**RESPONSES TO COMMENTS**

# 1629 Market Street Mixed-Use Project

CITY AND COUNTY OF SAN FRANCISCO  
 PLANNING DEPARTMENT  
 CASE NO. **2015-005848ENV**

DATE: **October 4, 2017**  
TO: Members of the Planning Commission and Interested Parties  
FROM: Don Lewis, EIR Coordinator  
Re: **Attached Responses to Comments on Draft Environmental Impact Report:  
Case No. 2015-005848ENV for the 1629 Market Street Mixed-Use Project**

The revised Draft EIR **Figure 4, Shadow Diagrams, December 21 – 8:19 a.m., 10:00 a.m., 2:00 p.m., and 3:54 p.m.**, follows this page.

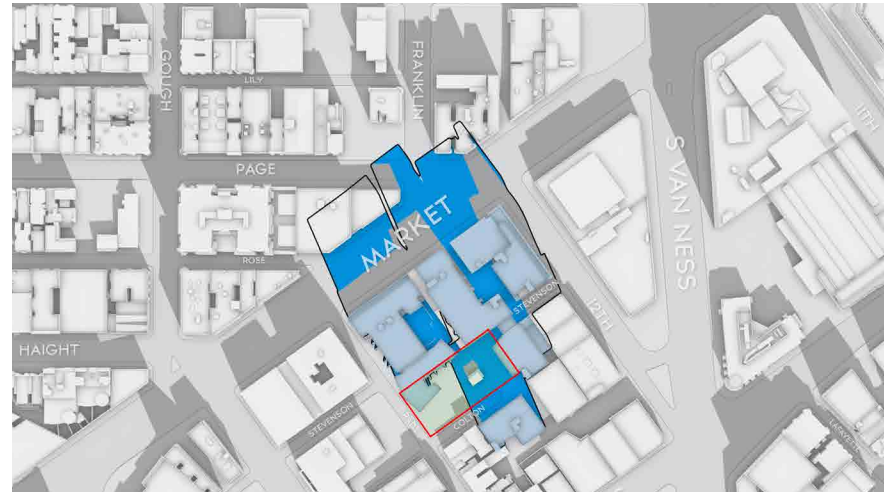
“Section E Topic 8 Figure 4

Section E Topic 8 Figure 4

The comment identifies a text error regarding the time of day that the December 21 shadow diagrams in the Draft EIR depict.

A staff-initiated text change is made to Figure 4, Shadow Diagrams, on Initial Study (Draft EIR, Appendix A), p. 65, to correctly label the figure as a depiction of shadow diagrams at 2:00 “PM” instead of 2:00 “AM”. In addition, the label under the lower right image of that figure is corrected from “3:45 AM” to “3:54 PM”. The revised Figure 4 is presented in Section D, *Draft EIR Revisions*, under Section D.3, *Figures*. The analysis in the text is based on the correct times and does not require correction.
